V2500-A1/A5/D5 SERIES PROPULSION SYSTEMS SERVICE BULLETIN

This document transmits the Revision 2 of Service Bulletin V2500-ENG-72-0418

V2500-ENG-72-0418

ENGINE – ACTUATING MECHANISM HP COMPRESSOR VARIABLE VANES – INTRODUCTION OF UNISON
RING ASSEMBLIES AND BRIDGE PIECE ASSEMBLIES WITH REVISED ONE PIECE LEVER PIN BUSHES

Figure 1

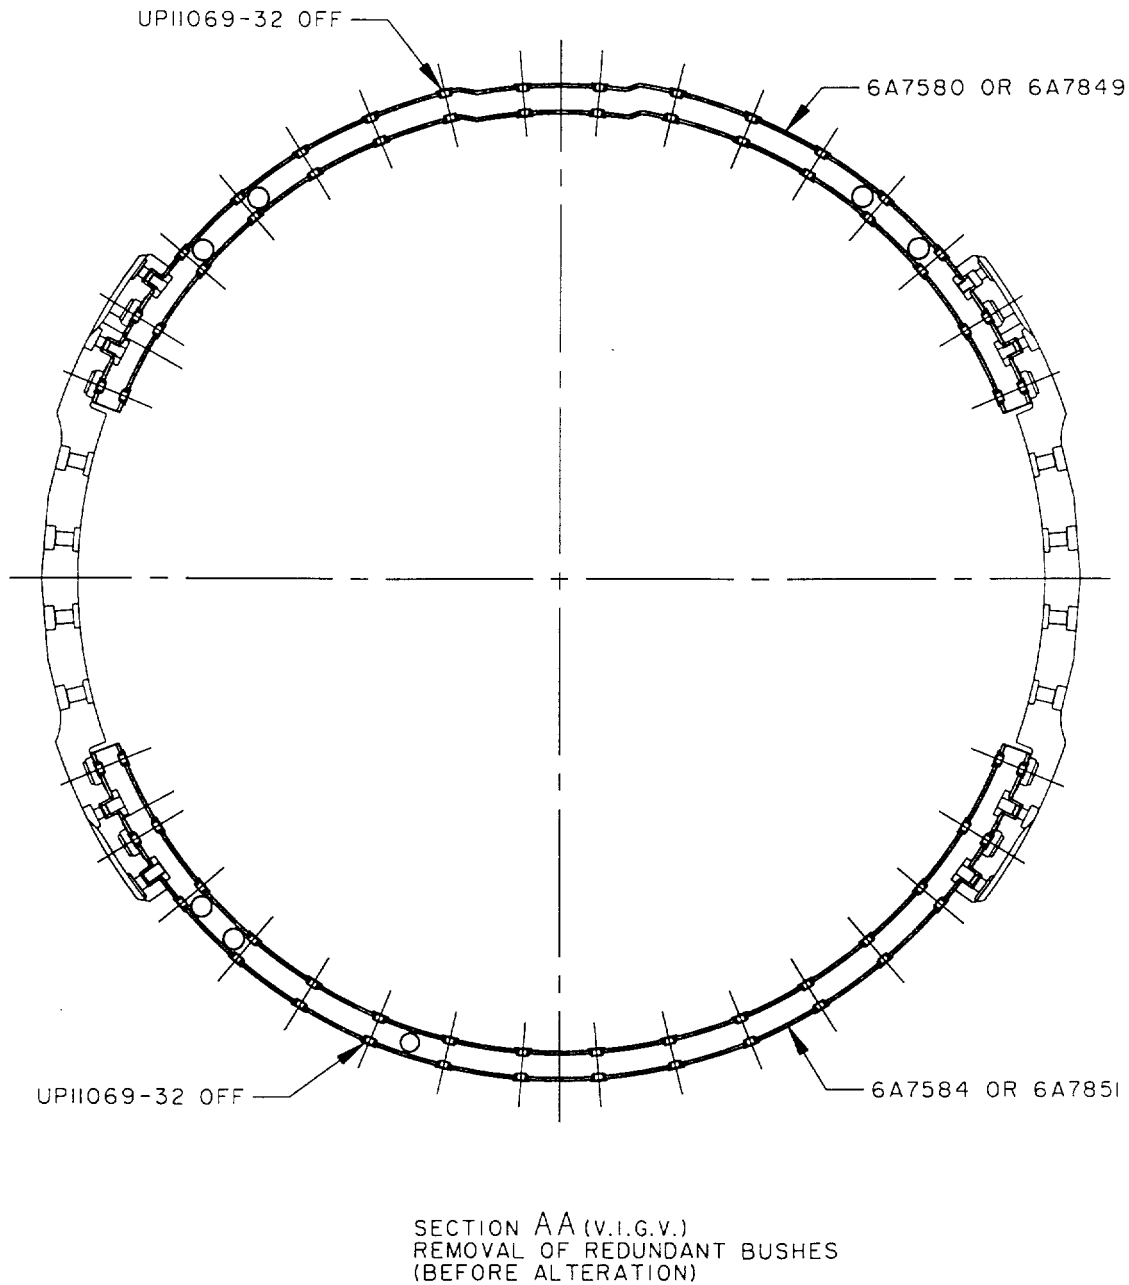
PROCEDURE	RELATED DATA
(i) Drill the head of the bush (UP11069 – 32 off) until the head is released	See Figure 1 and Figure 2. Use a drilling machine with a 0.346in. (8,8 mm.) diameter drill.
(ii) Push the bush from the hole	Use a round bar.
(iii) Remove the bush from the channel.	
(b) Clean the bush location holes in the ring	See Figure 2. Use a soft clean cloth and air blast, remove the sharp edges around the holes. Use standard workshop equipment.
(c) Visually examine and measure the dimensions of the bush location holes	See Figures 2, 3 and 14. Examine the interference on the diameter. Reject if the location hole is oversize.
(d) Install the new bushes into the holes	
(i) Push the bush fully into position in the hole	See Figures 3 and 14. Use bushes BRR12496 – 16 off.
(ii) Visually inspect the bush location	See Figure 14.

Figure 4

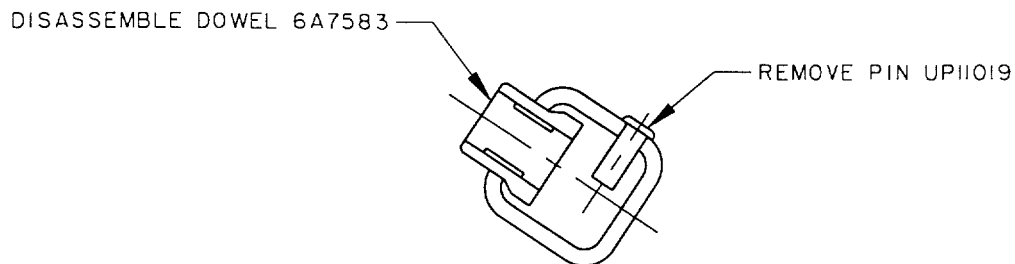
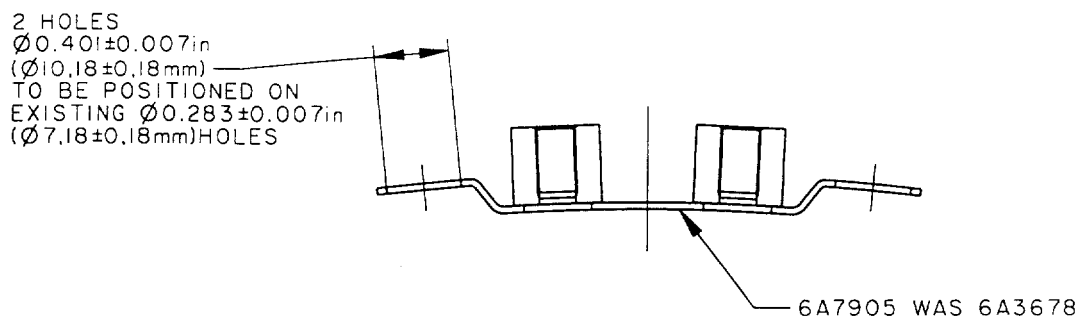
PROCEDURE	RELATED DATA
(a) Remove pin (UP11019 – 2 off) at positions identified AF	See Figures 1, 4 and 5. Use portable grinding equipment to remove welds.
(b) Remove and retain dowels (6A7583 – 2 off)	See Figures 4 and 5.
(c) Remove the bushes and brackets	
(i) Drill the head of the bush (UP11069 – 24 off) until the head is released	See Figure 4 Use a drilling machine with a 0.346in. (8,8 mm.) diameter drill.
(ii) Push the bush from the hole	Use a round bar.
(iii) Remove the bushes and brackets from the channel and retain the brackets.

| (n) Visually examine and measure the dimensions of the reworked areas. | See Figures 4 and 6.
| (i) Install the dowels in the unison ring | See Figures 4 and 6.

Figure 7

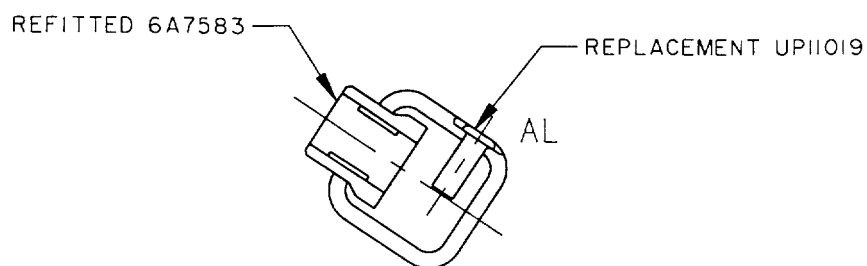
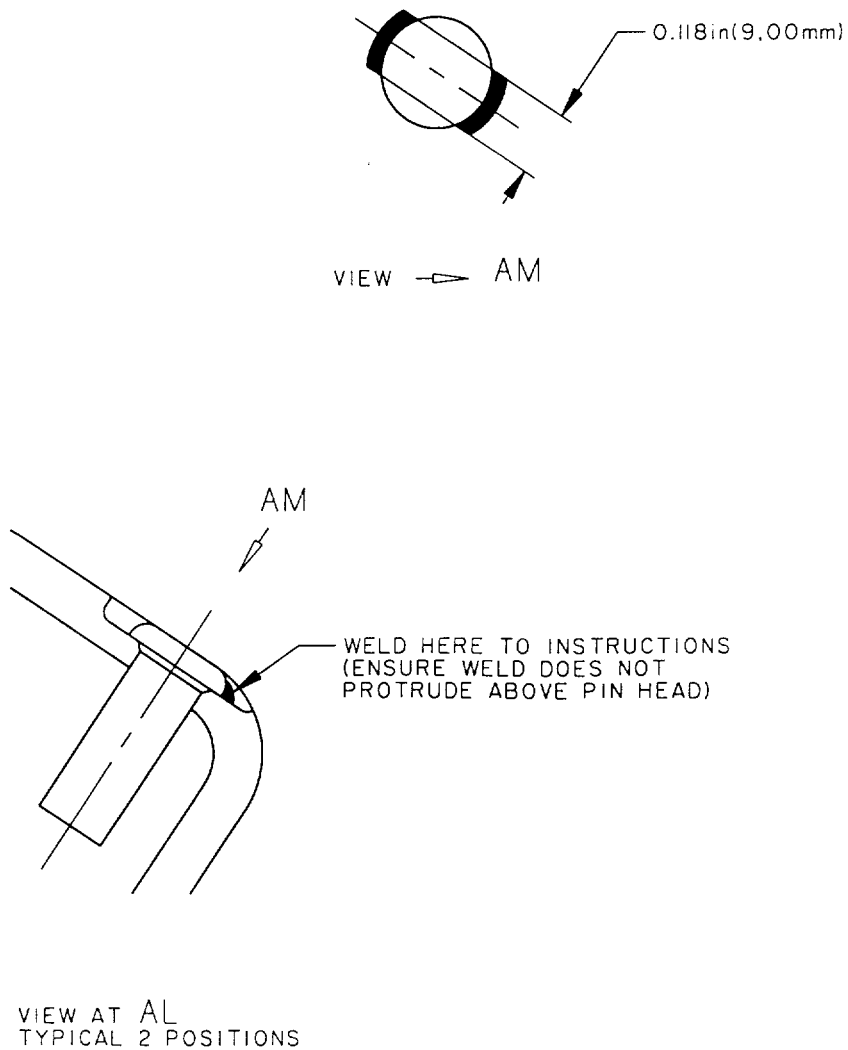
| (iii) Tack weld location pins | See Figure 7.

Refer to SPM TASK 70-31-02-310-501.
Use 2 equispaced tacks per pin.
Use CoMat 03-366 filler material if required. |

Figure 8

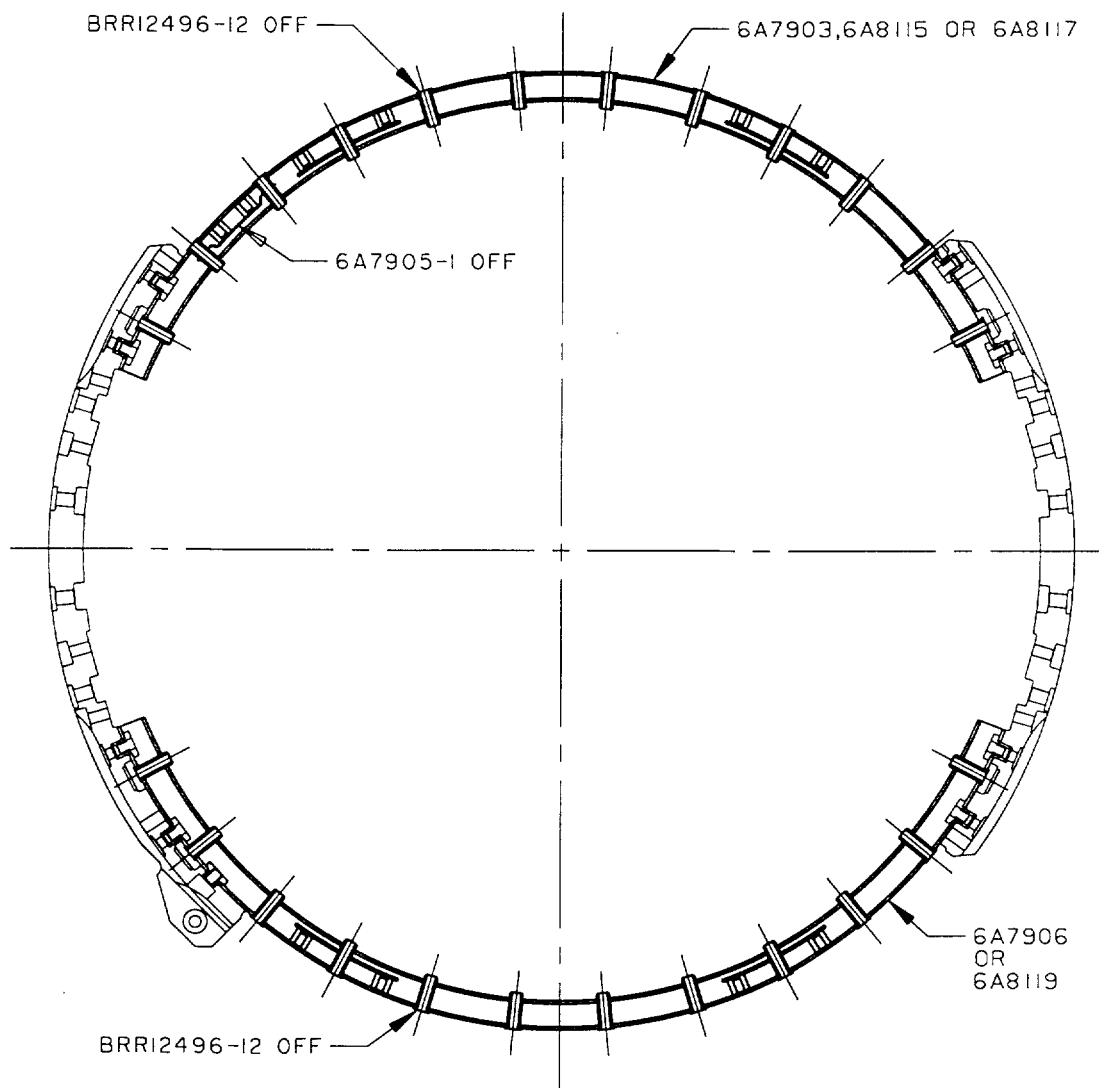
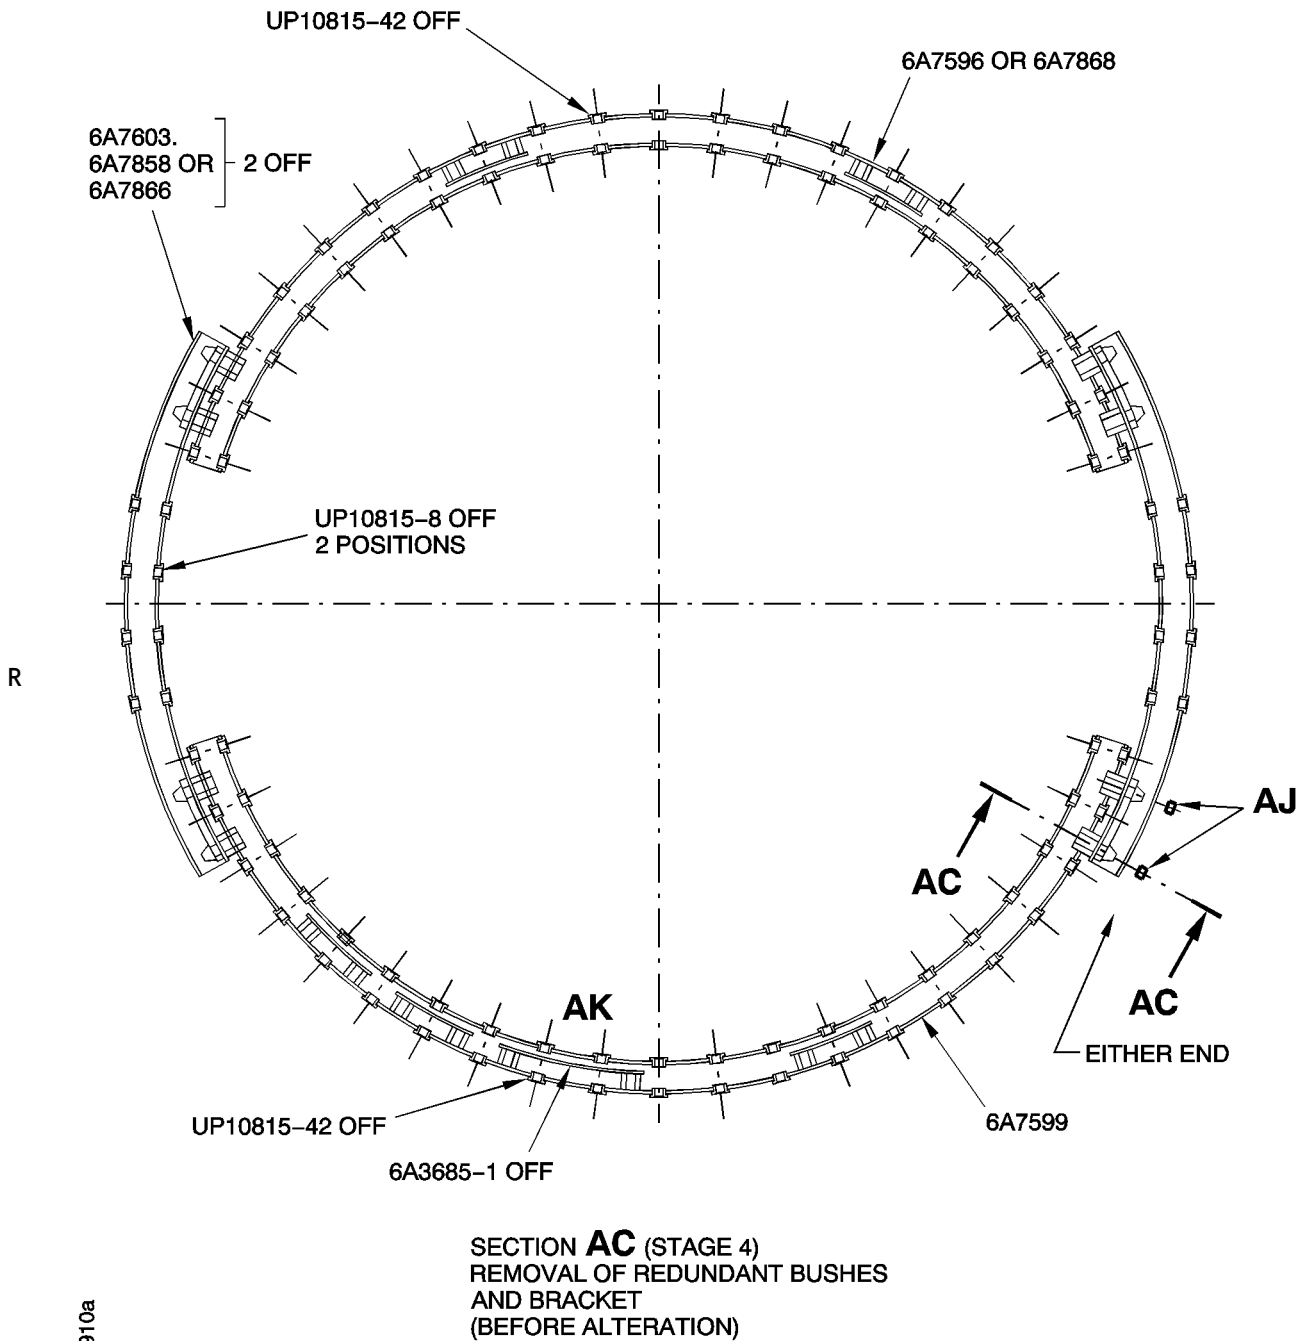
| (o) Install brackets into position | See Figure 8.

| (i) Push the bushings fully into position in the holes | See Figures 8 and 14.

Figure 9

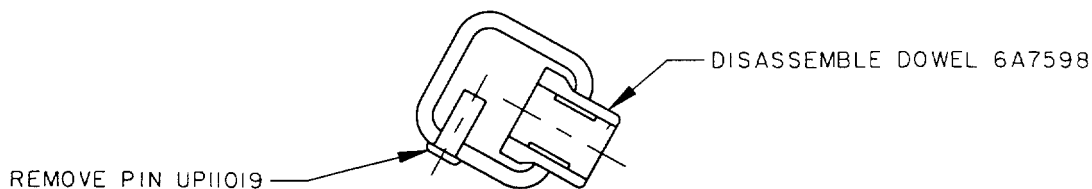
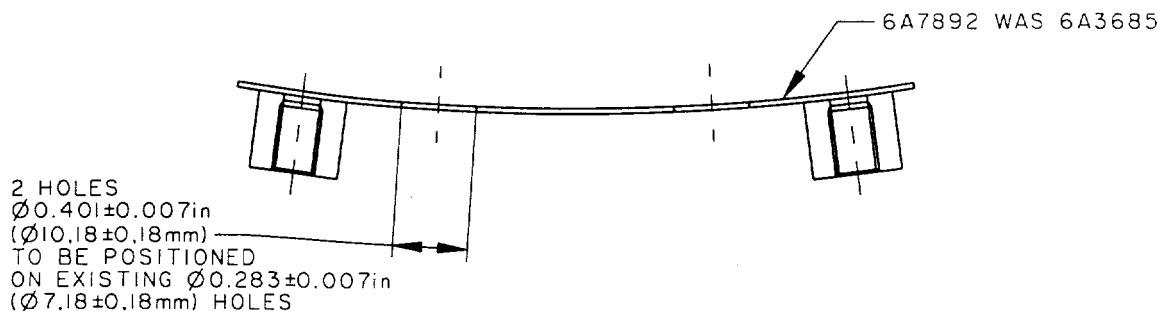
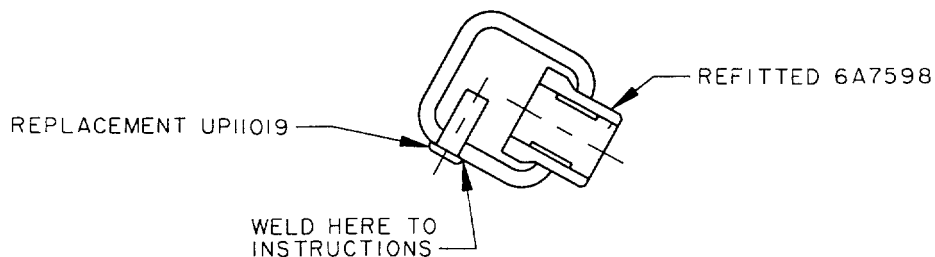
Remove	Incorporate	Reason for change
All pages of the Service Bulletin.	Pages 1 to 60 of the Service Bulletin.	To revise Figure 9 and 11.

PROCEDURE	RELATED DATA
(a) Drill the head of the bush (UP10815 – 8 off) until the head is released	See Figure 1 and Figure 9. Use a drilling machine with a 0.310in. (7,8 mm.) diameter drill.
(b) Push the bush from the hole	Use a round bar.
(c) Remove the bush from the channel.	
(d) Clean the holes in the bridge piece	See Figure 9. Use a soft clean cloth and air blast, remove the sharp edges around the holes. Use standard workshop equipment.
(e) Visually examine and measure the dimensions of the bush location holes	See Figures 9, 11 and 14. Examine the interference on the diameter. Reject if the location hole is oversize.
(f) Install the new bushings in the bridge piece	
(i) Push the bushings fully into position in the holes	See Figures 11 and 14. Use bushes UP12206 – 4 off.
(ii) Visually inspect the bushings	See Figure 14.

PROCEDURE	RELATED DATA
(a) Remove pin (UP11019 – 2 off) at positions identified AJ	See Figures 1, 9 and 10. Use portable grinding equipment to remove welds.
(b) Remove and retain dowels (6A7598 – 2 off)	See Figures 9 and 10.
(c) Remove the bushes and brackets	
(i) Drill the head of the bush (UP10815 – 42 off) until the head is released	See Figure 9 Use a drilling machine with a 0.310in. (7,8 mm.) diameter drill.
(ii) Push the bush from the hole	Use a round bar.
(iii) Remove the bushes and brackets from the channel and retain the brackets.	
(d) Clean the bush location holes in the unison ring	See Figure 9. Use a soft clean cloth and air blast, remove the sharp edges around the holes. Use standard workshop equipment.

Figure 12

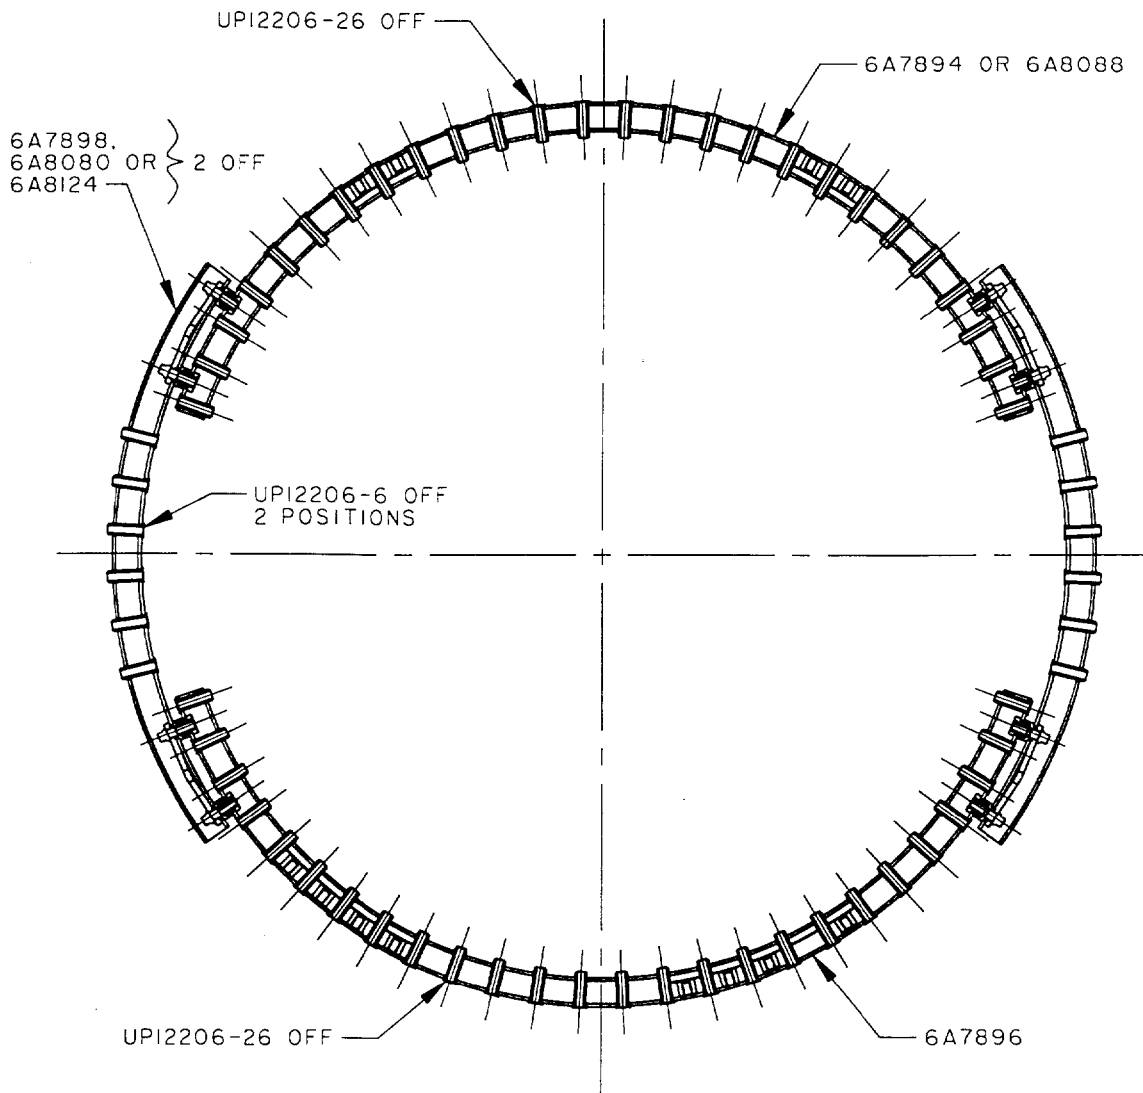
| (a) Drill the head of the bush (UP10815 – 12 off) until the head is released | See Figure 1 and Figure 12.
| (d) Clean the holes in the bridge piece | See Figure 12.

| (i) Drill the head of the bush (UP10815 - 52 off) until the head is released | See Figure 12.
| (d) Clean the holes in the unison ring | See Figure 12.

Figure 13

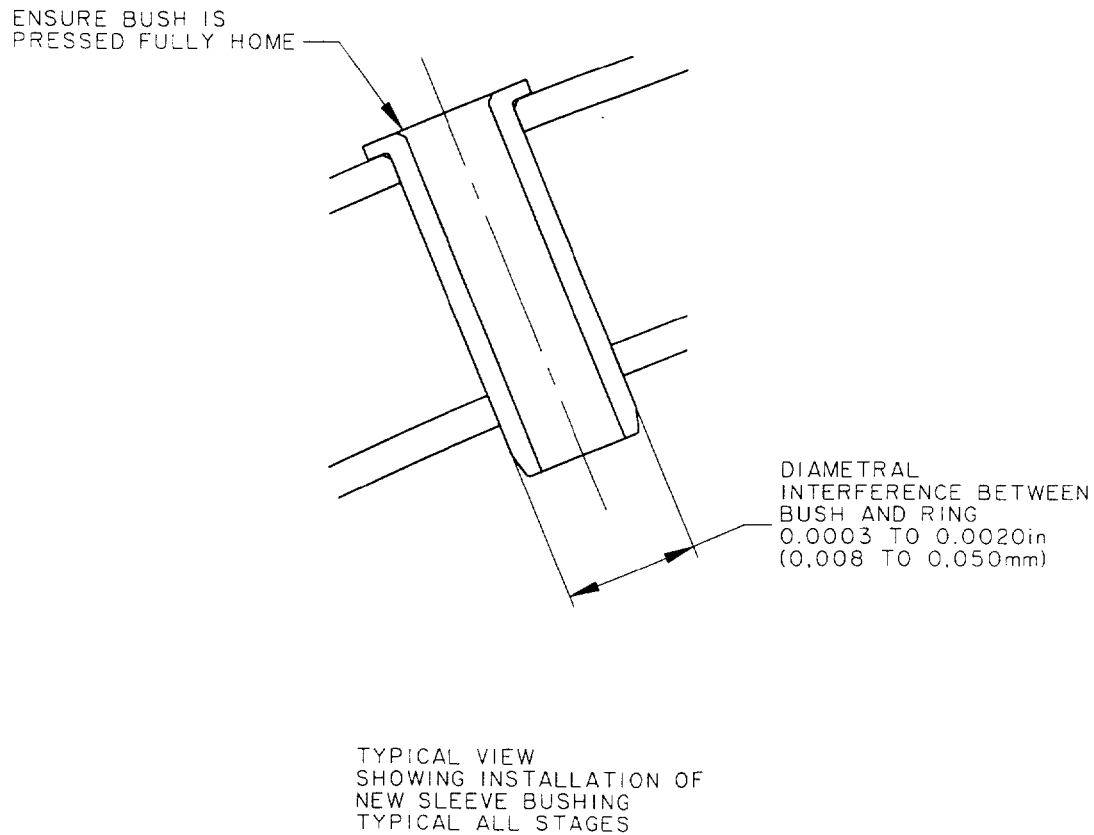
- (f) Install brackets into position See Figure 13.
Use hand tightened No.10 (0.190in. (4,82 mm.)) diameter UNF bolts and (0.250in. (6,35 mm.)) diameter UNF bolts, as necessary, to hold the brackets in position.

- (i) Push the bushings fully into position in the holes See Figures 13 and 14.
Use UP12206 bush – 26 off. Use standard workshop equipment.
- (ii) Visually inspect the bushings See Figure 14

Figure 14

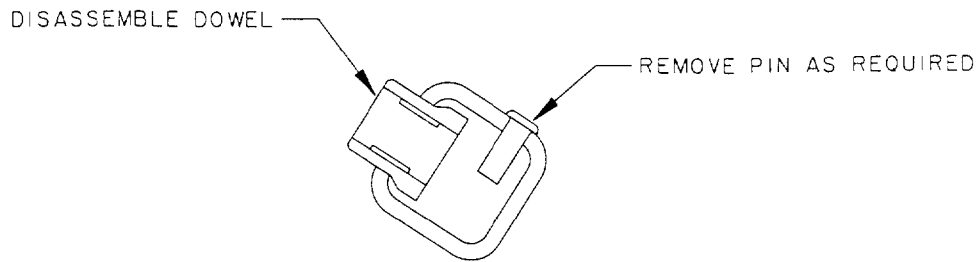
| (ii) Visually inspect the bushings | See Figure 14 |
